MILITARY SPECIFICATION

MICROCIRCUITS, DIGITAL, ECL, MULTIPLE NOR GATES,
MONOLITHIC SILICON

This amendment forms a part of MIL-M-38510/60A,
dated 5 August 1985, and is approved for used by
all Departments and Agencies of the Department of Defense.

FIGURE 4, delete the propagation delay timewaveforms, and substitute :

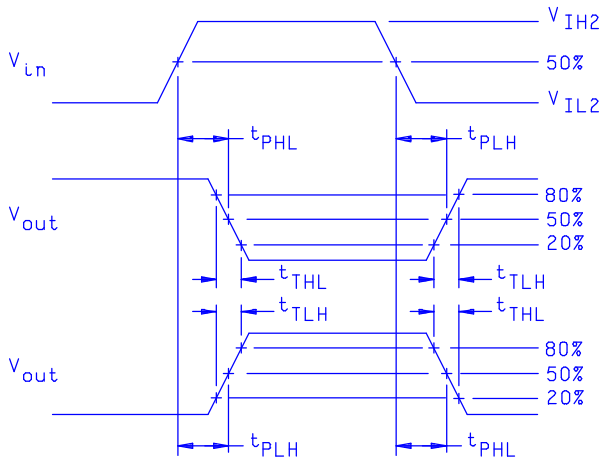
FIGURE 4, delete ‘t_p = 40 ns = 1 ns “ and substitute “t_p = 40 ns $\pm$ 1 ns “.
